Treaty Series No. 99 (1991)

## Amendments

# to Annex 6 of the Customs Convention on the International Transport of Goods under Cover of TIR Carnets (TIR Convention)

## AMENDMENTS<sup>1</sup> TO ANNEX 6 OF THE CUSTOMS CONVENTION ON THE INTERNATIONAL TRANSPORT OF GOODS UNDER COVER OF TIR CARNETS (TIR CONVENTION)<sup>2</sup>

#### Sketch No. 5

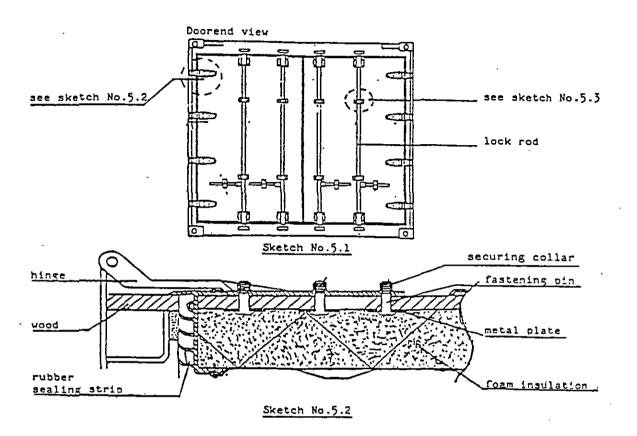
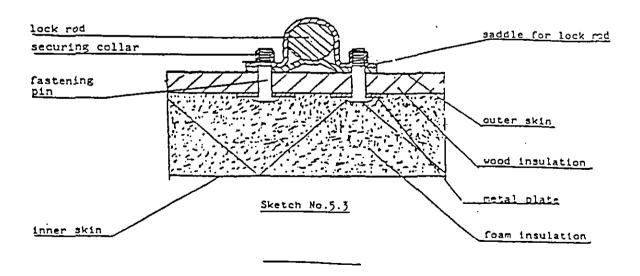
(ii) A fastening device which is inserted from the inside of the insulated door construction on condition that:

the fastening pin and securing collar of the device are assembled by pneumatic or hydraulic tooling and fixed behind a plate or similar device fitted between the outer layer of the door structure and the insulation; and

the head of the fastening pin is not accessible from the inside of the load compartment; and

a sufficient number of securing collars and fastening pins are welded together and the devices cannot be removed without leaving visible signs of tampering (see sketch No. 5 appended to this annex).
